**Planned Unit Development Amendment—Lots 1  
through 4 Echo Hills Replat Four —West  
Management, LLC**

**CITY OF LA VISTA  
PLANNING DIVISION  
RECOMMENDATION REPORT**

CASE NUMBERS: PPUD20-0003;

**G. PURPOSE OF REQUEST:** Allow for changes in the number of provided parking stalls and the stall configurations in the previously approved PUD Site Plan.

**C1.0**

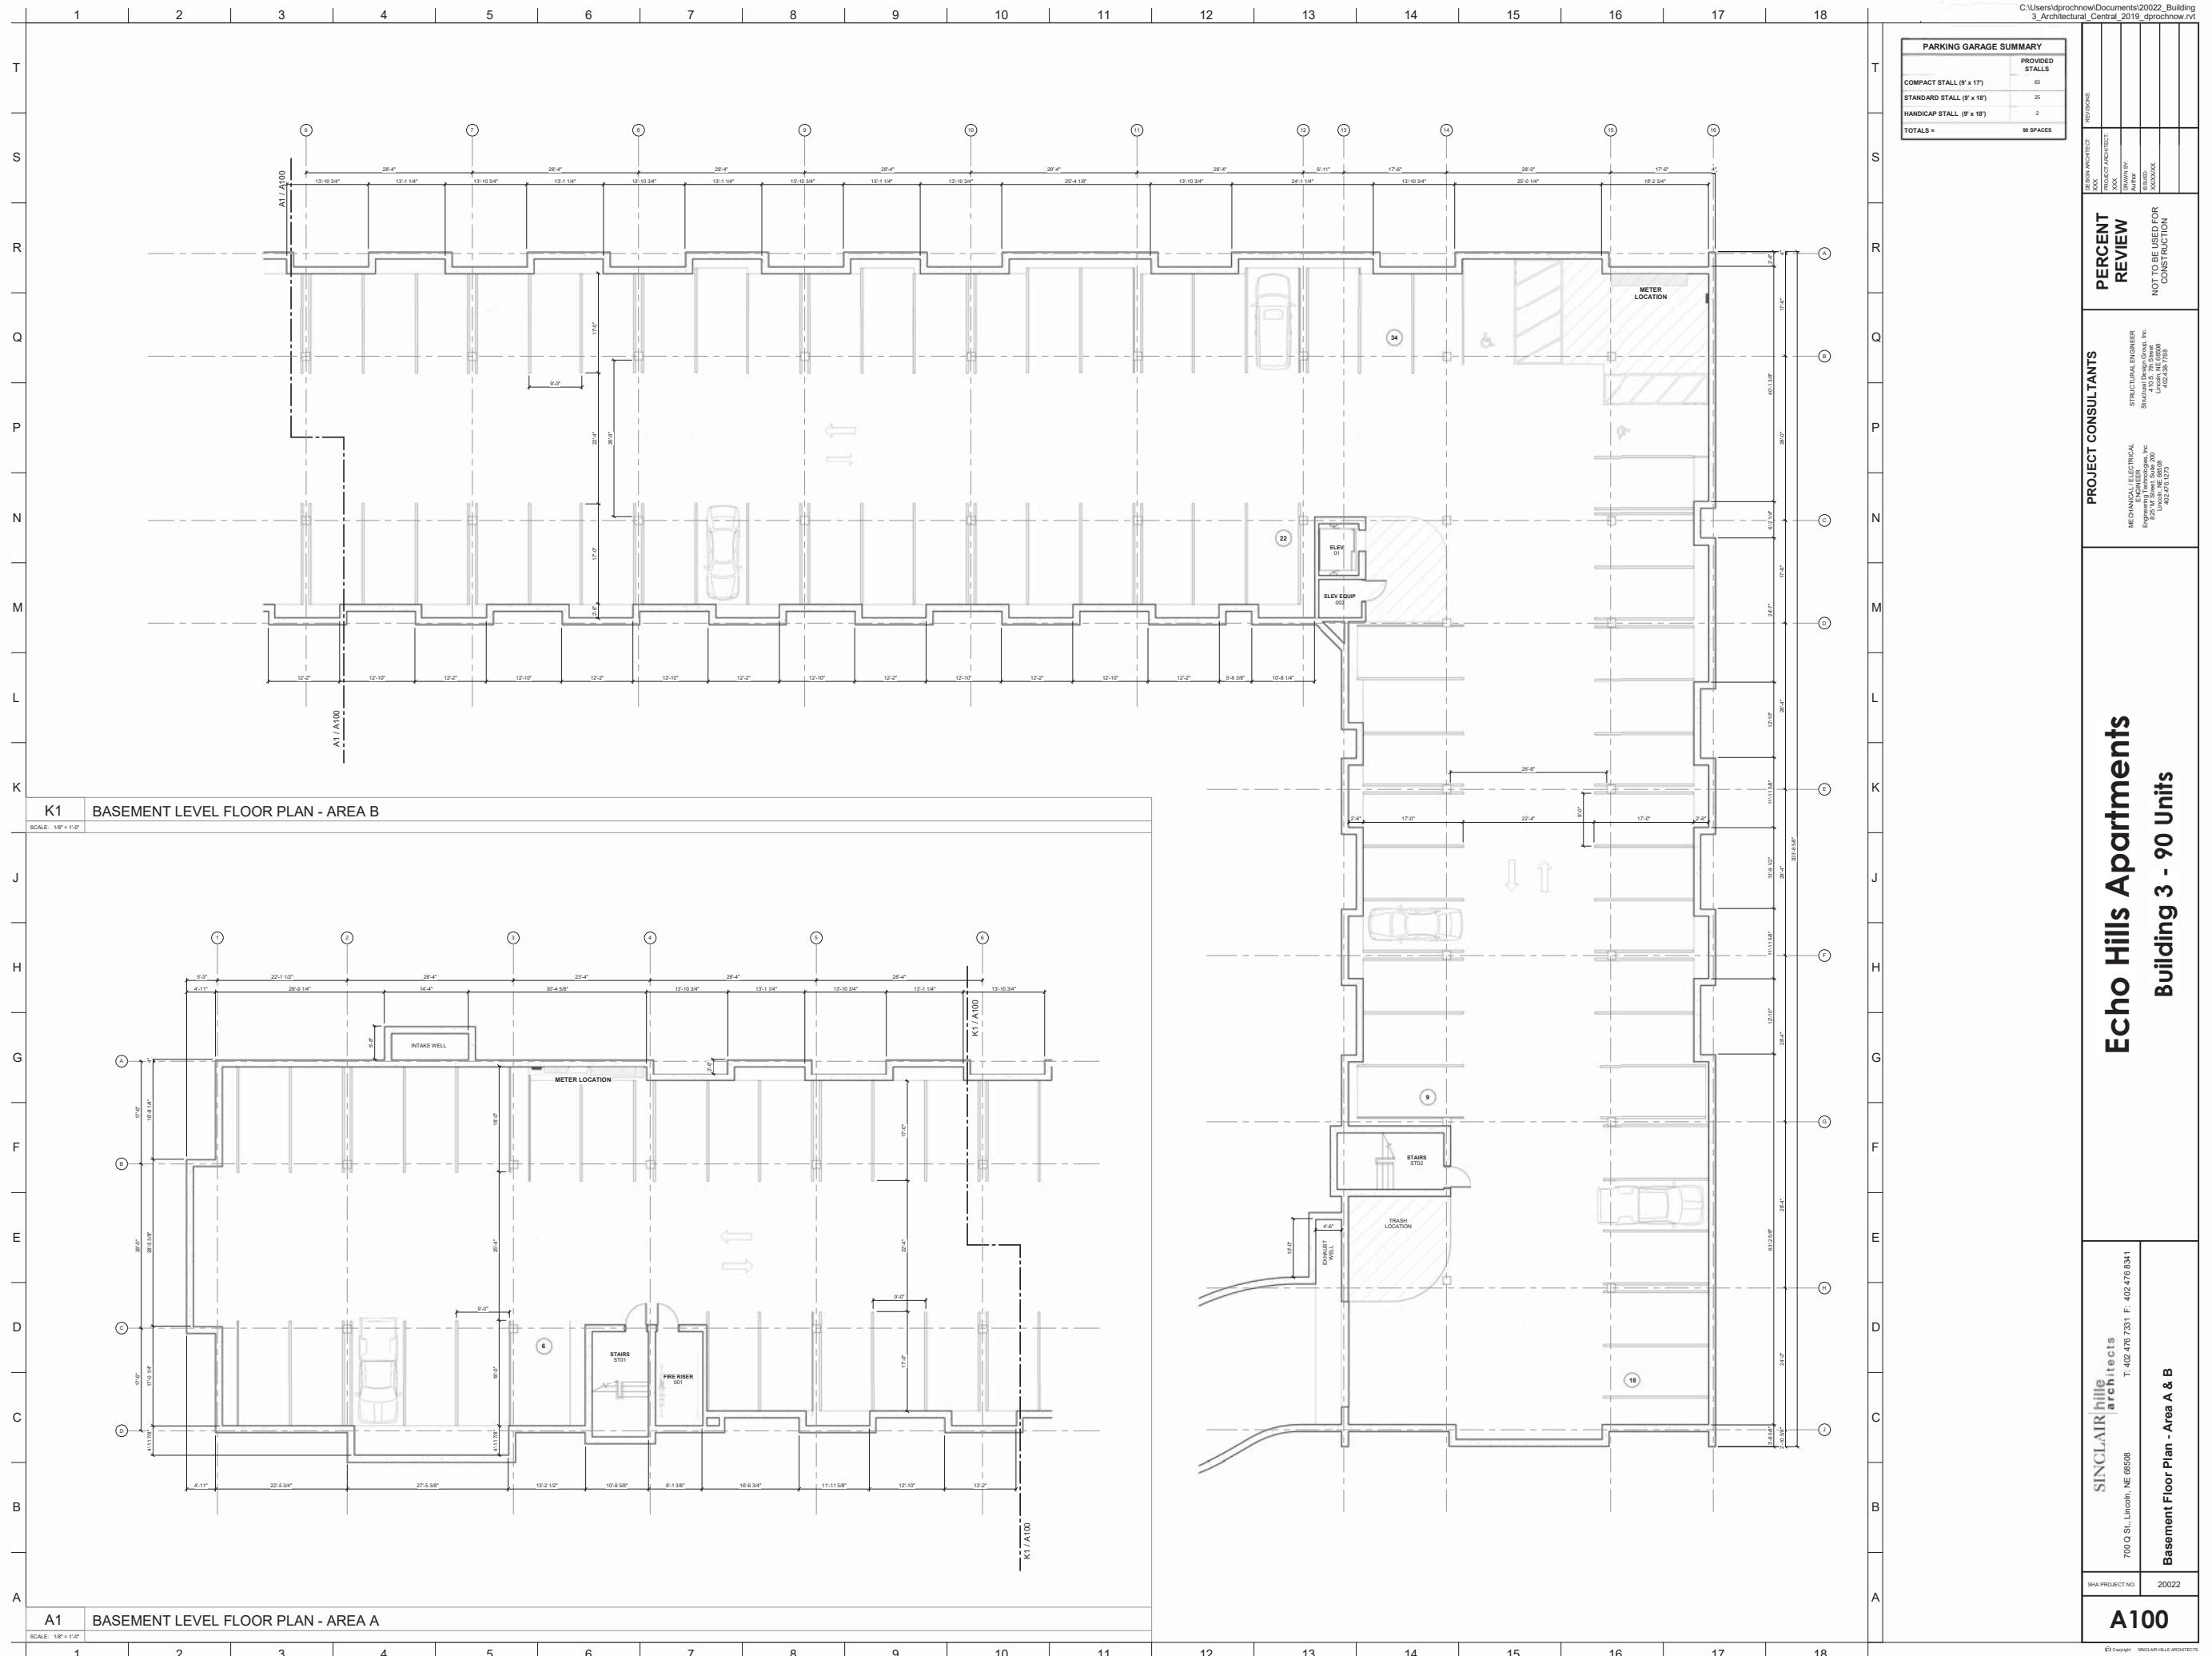
D. The City Engineer recommends approval of the proposed alternative compact stall dimensions, considering that all 91 stalls in the underground garage for apartment building #3 are classified as compact, as denoted on the PUD Site Plan attached to this report.

## PARKING EXHIBIT: TURNING DIAGRAM FOR COMPACT VEHICLES / SPACES

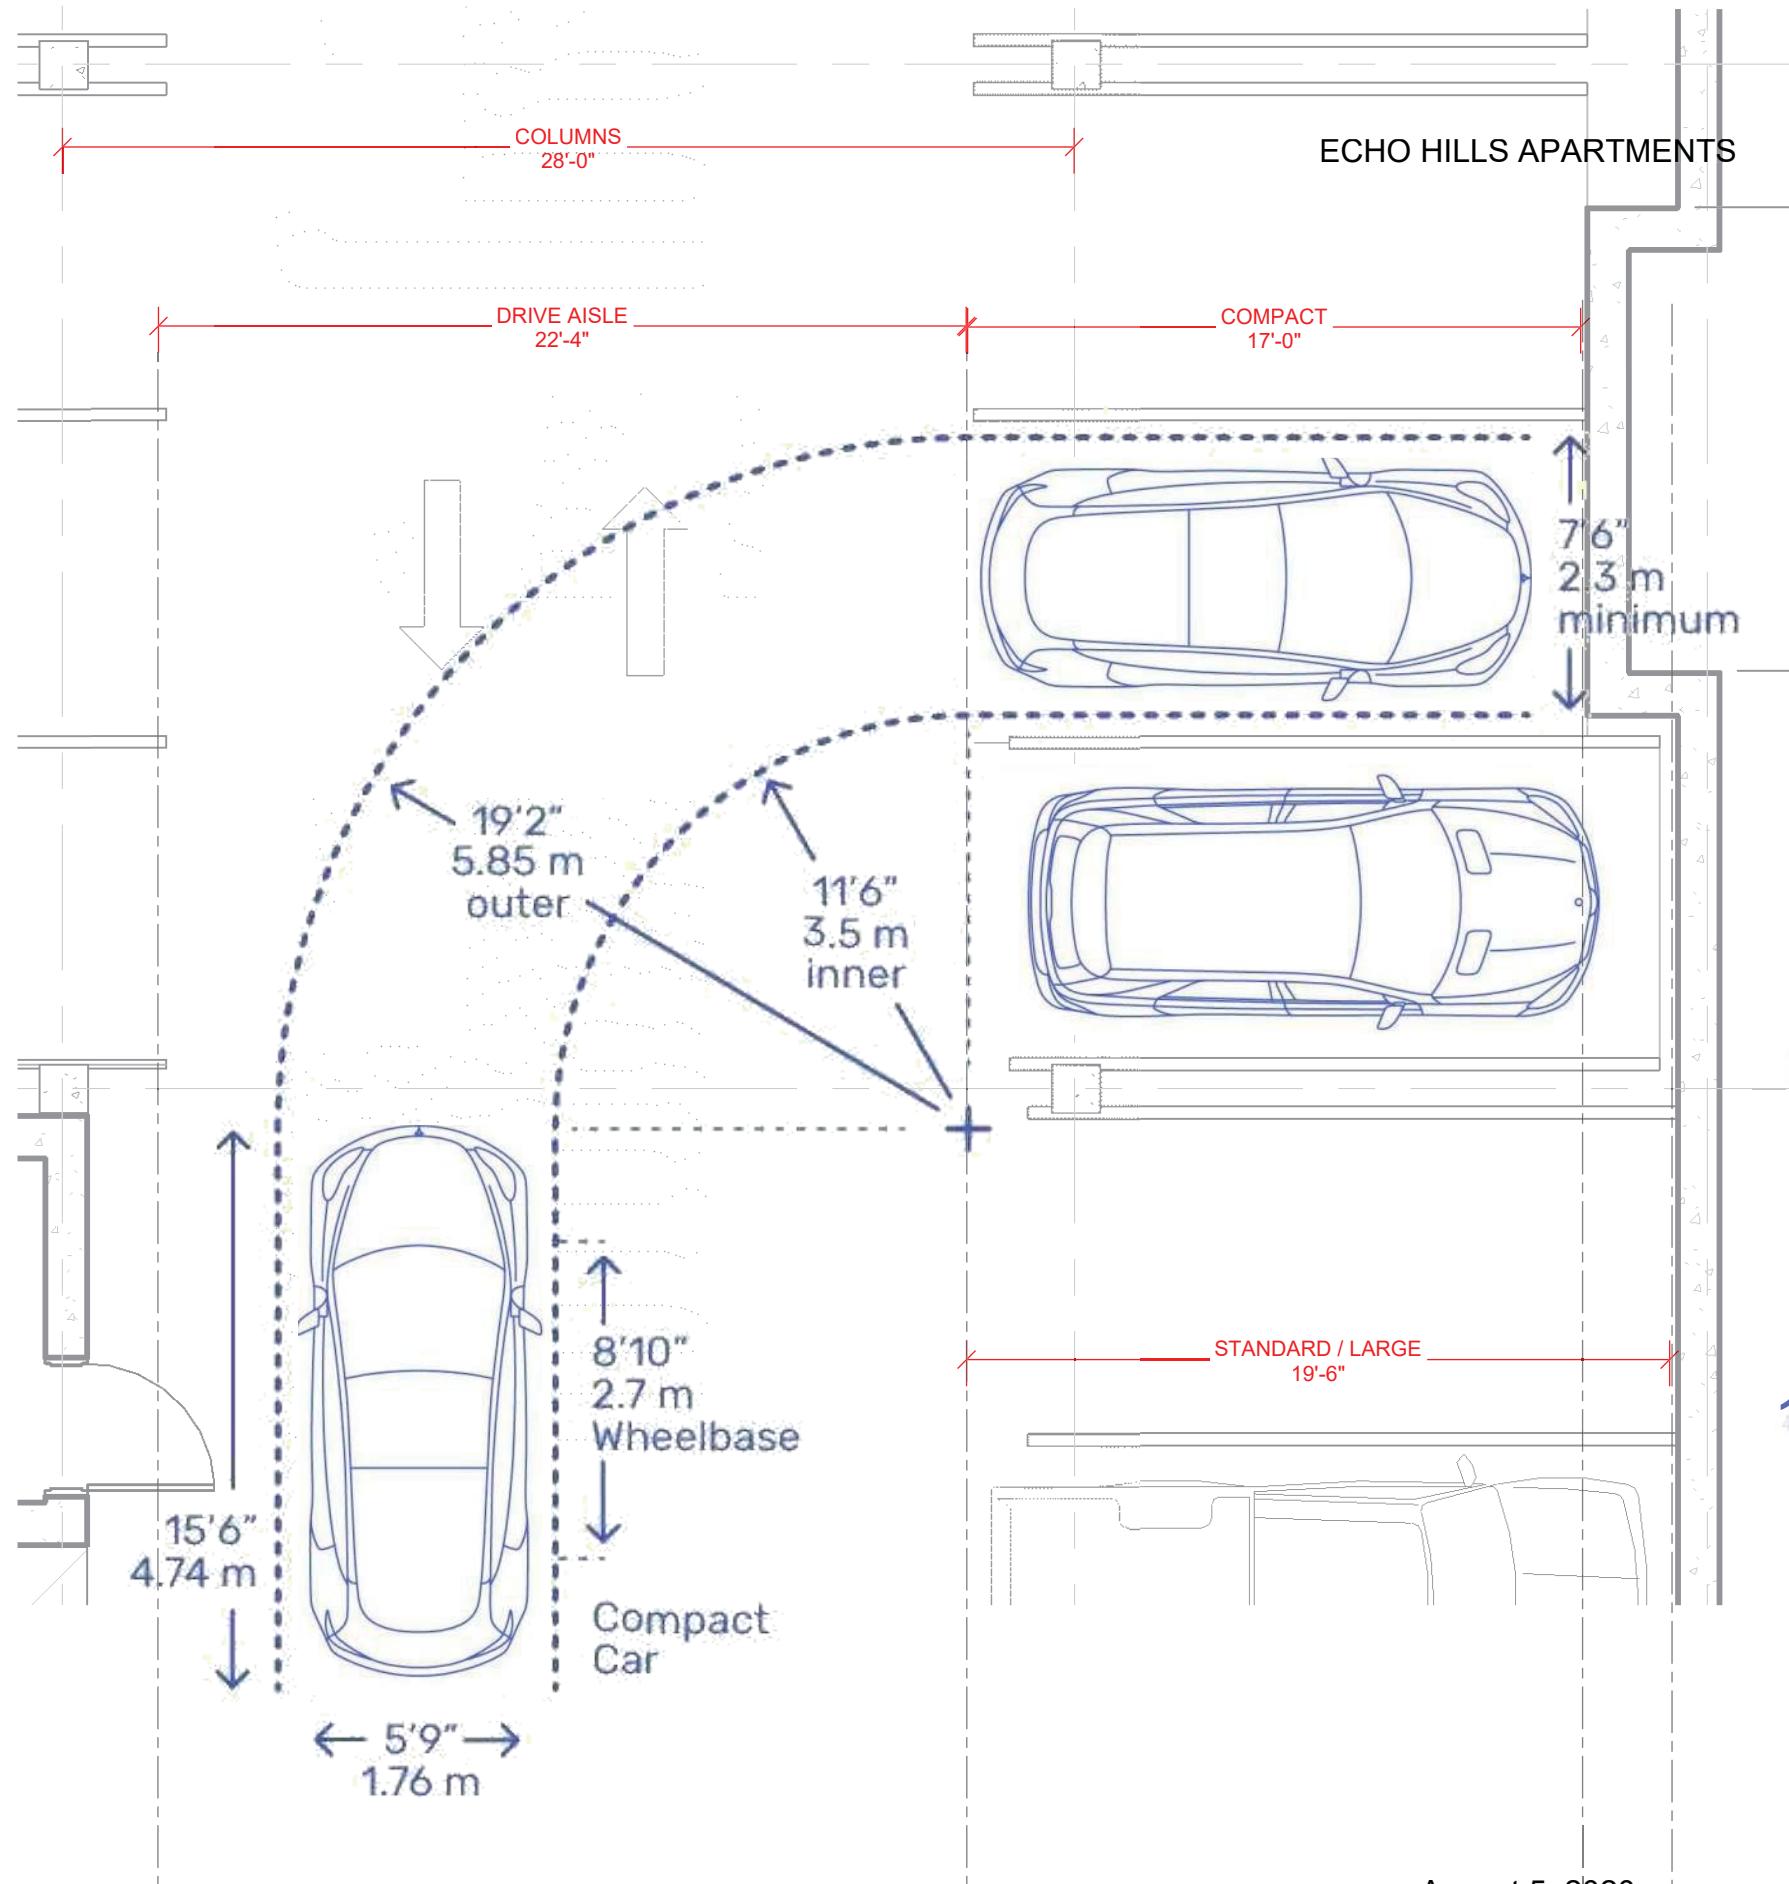
3. The proposed number of provided off-street parking stalls for Lot 2, Lot 3, and Lot 4 meet the required minimums per the La Vista Zoning Ordinance.
4. The applicant has requested approval of alternative parking stall dimensions for the 91 stalls in the underground parking garage under apartment building #3 on Lot 2. Standard configurations for 90-degree parking stalls, per Section 7.09 of the La Vista Zoning Ordinance are 9' wide by 18' deep with an isle width of 24' for two-way traffic. The proposed dimensions for the underground garage stalls include a 22'-4" drive isle width (a 1'6" reduction), and some stalls with a depth of 17' (a 1' reduction). Other stalls in the garage will have a depth of 19'-6" (an increase of 1'-6"). The Underground Parking Garage Exhibit, attached to this report, shows these stall dimensions and a sample turning diagram.

B. Omaha's standards include the following for 90 degree parking stalls: 16' parking space depth, 8' curb length (width), and 20' drive aisle width. The proposed compact parking stall dimensions for the spaces in the underground garage of apartment building #3 exceed all of the standard compact stall dimensions for the City of Omaha, as displayed in the table below:

Dimension	<u>City of Omaha Compact Stall Dimensions</u>	<u>Proposed Dimensions for Apartment Bld. #3</u>
Width	8'	9'
Depth	16'	17' minimum
Drive Aisle	20'	22'-4"

While some of the parking stalls in the underground garage will exceed the depth of a standard stall (19'-6" as compared to 18'), they still must be considered compact because vehicles accessing them must use a drive aisle width that is considered compact. The City of Omaha limits the percentage of compact parking stalls for any one facility to 40% of the total stalls, per Section 55-737 of their Zoning Ordinance. For Lot 2 Echo Hills Replat Four, which will contain the four apartment buildings, 29% of the total parking stalls would be considered compact if the alternative dimensions are approved and all 91 underground stalls are considered compact. The percentage of compact stalls for the entire development, which can utilize shared parking through the PUD, would be approximately 17%.
